Addendum 01

PROJECT: North Union Schools Art Room Expansion Addition
401 N Franklin Street
Richwood, OH 43344

PROJECT #: 25091.00

2 FIRST FLOOR PLAN - UNIT E
1/8" = 1'-0"

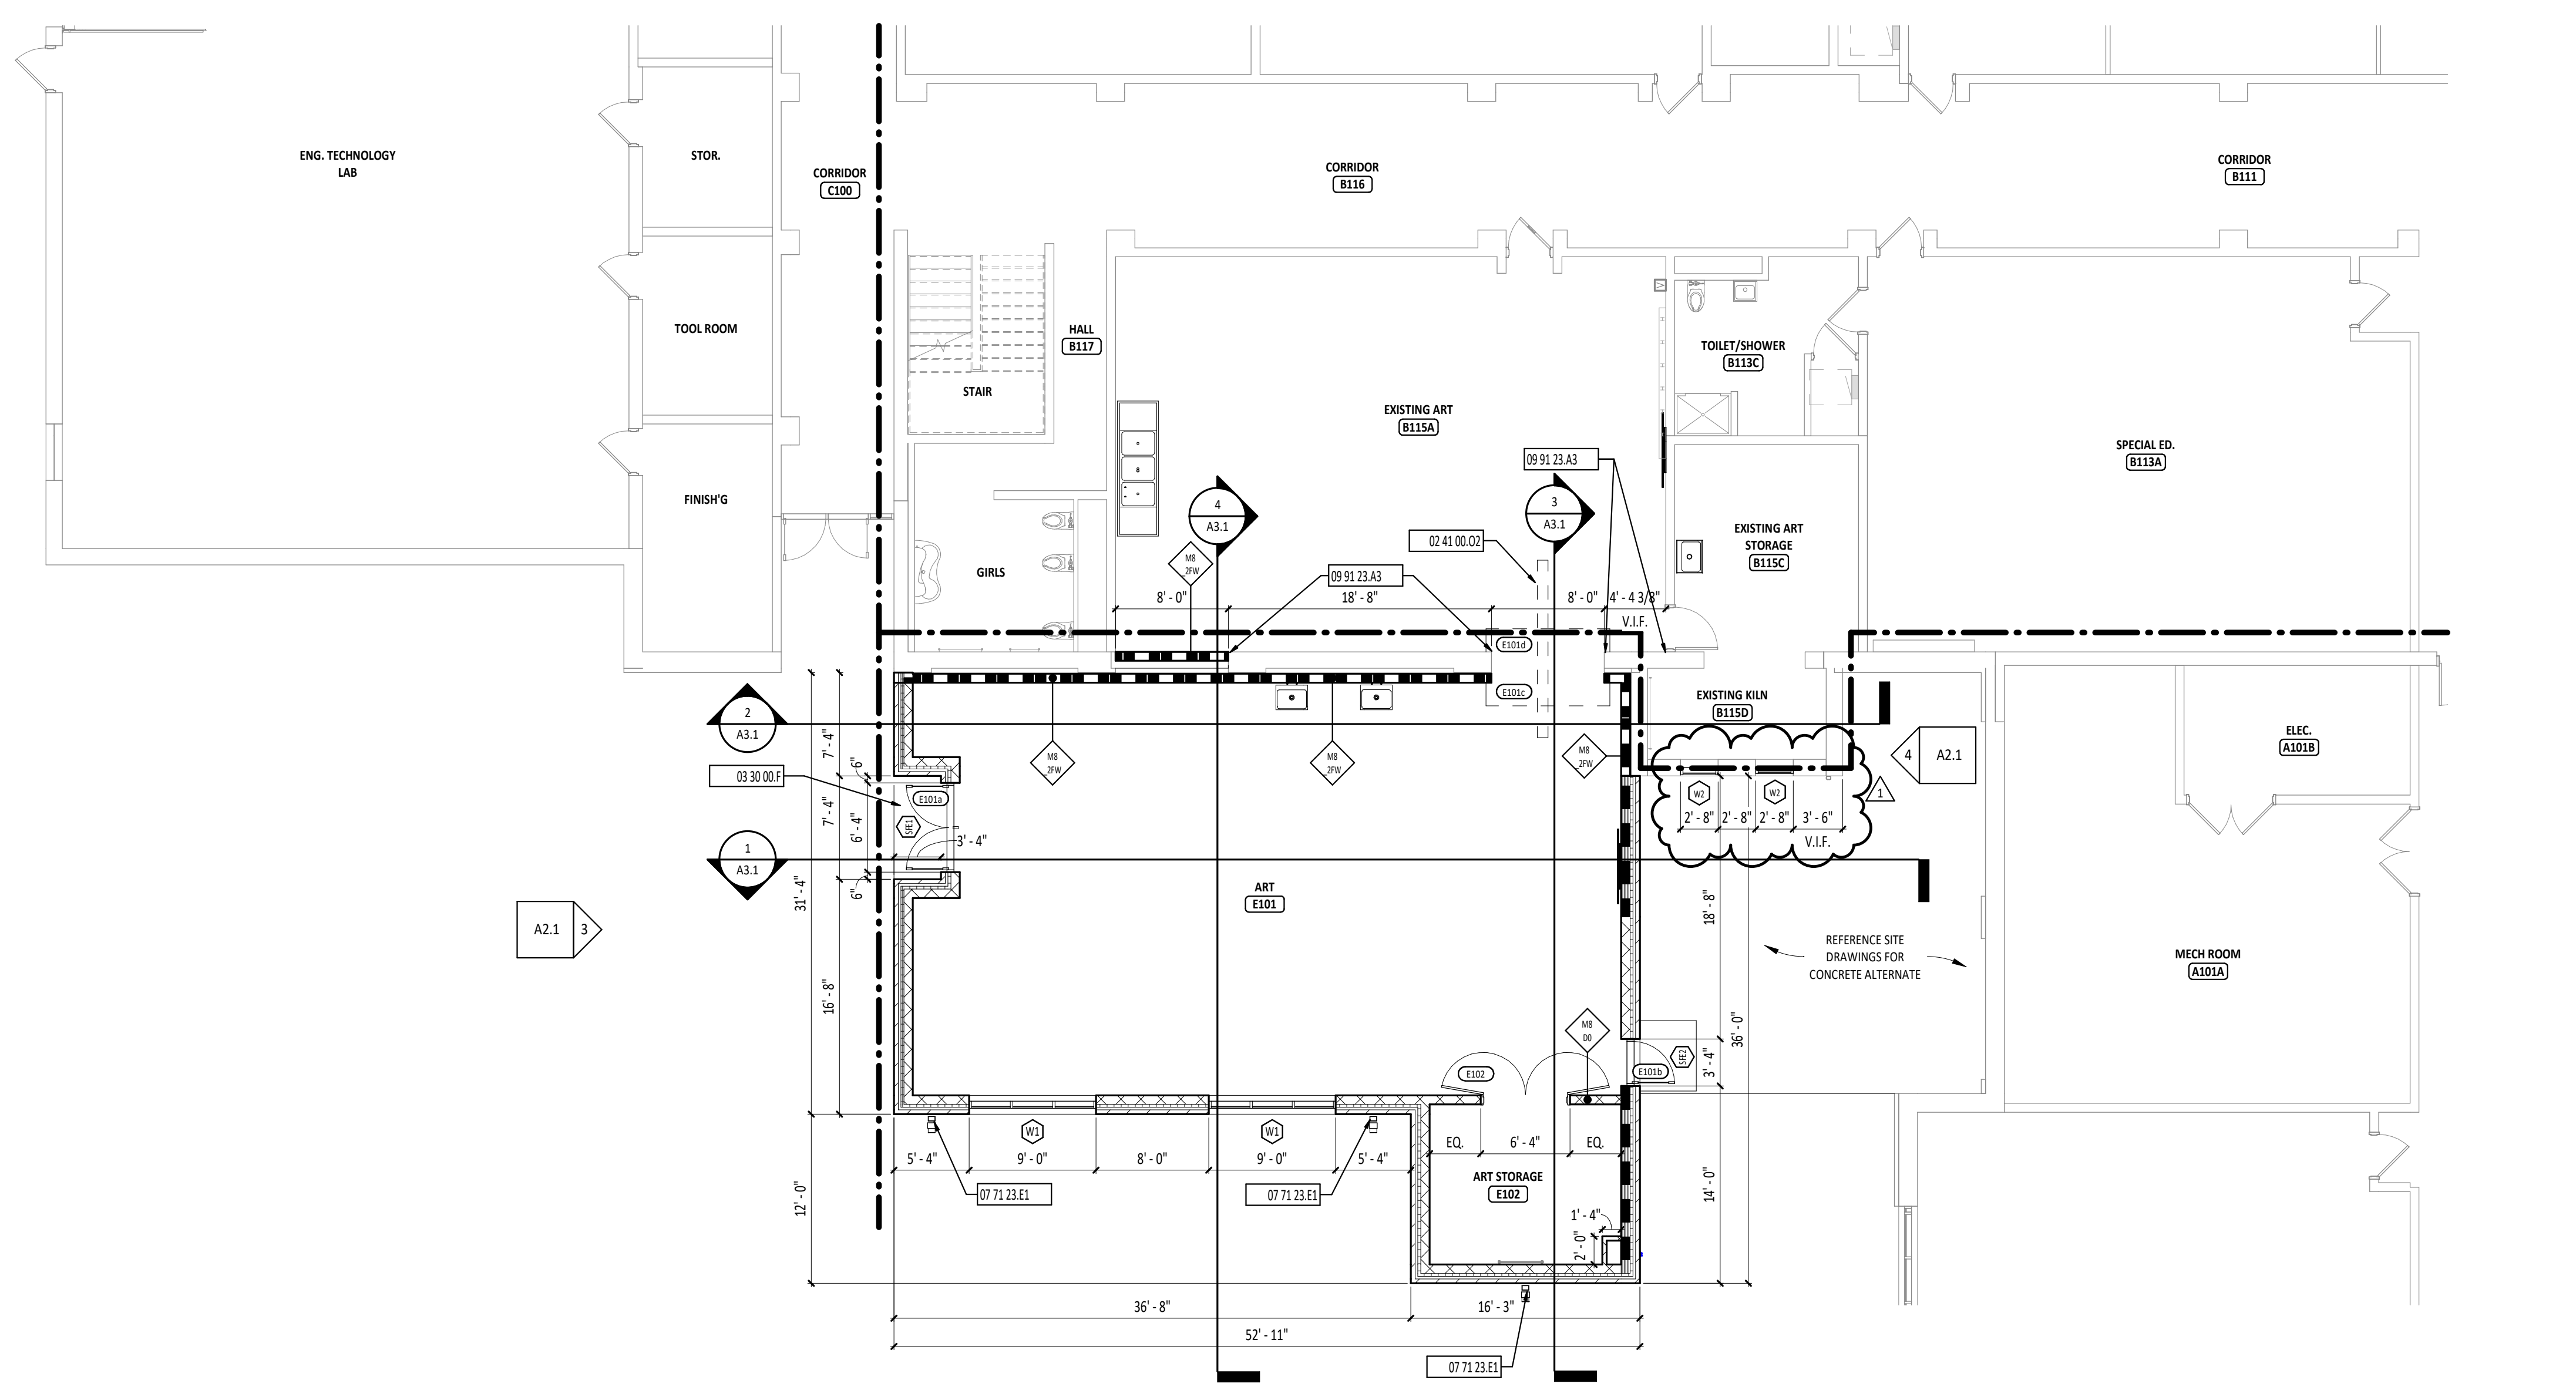
1. Drawing Sheet A1.1 First Floor Demo Plan and Plan – Unit E: Detail 2 First Floor Plan – Unit E: Replace two windows in existing kiln room.
2. Drawing Sheet A2.1 Building Elevations: Detail 5 Enlarged Building Elevation: Replace two windows in existing kiln room.
3. Drawing Sheet A6.1 Door Schedule and Door and Window Types and Frames: Detail 7 Window Types: Add window type W2.
